**Cobham SATCOM**

Document Number: 95-142659-A

## **EXPLORER 710 Battery contact issue**

Production code 1419 and newer

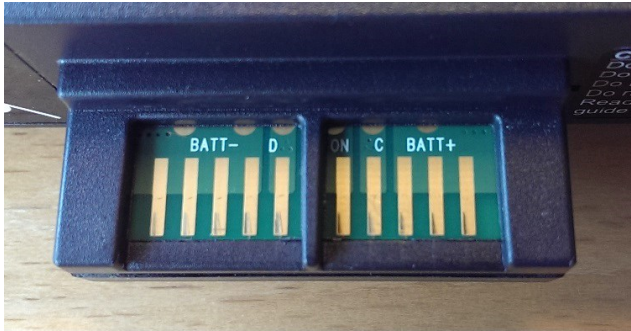
A new type of battery contact surface has been introduced in order to remove the risk of this contact problem.

The below pictures illustrates the two methods used for improved/new contact surface where the solder mask has been changed.

Batteries which may be affected will have production code **older** than **1419** (2014, week 19) **and not** reworked as illustrated in picture "Reworked from factory" on next page.

Note! - Replacement of battery can only take place when both production code is older than 1419 **and** contacts/PCB is not reworked.
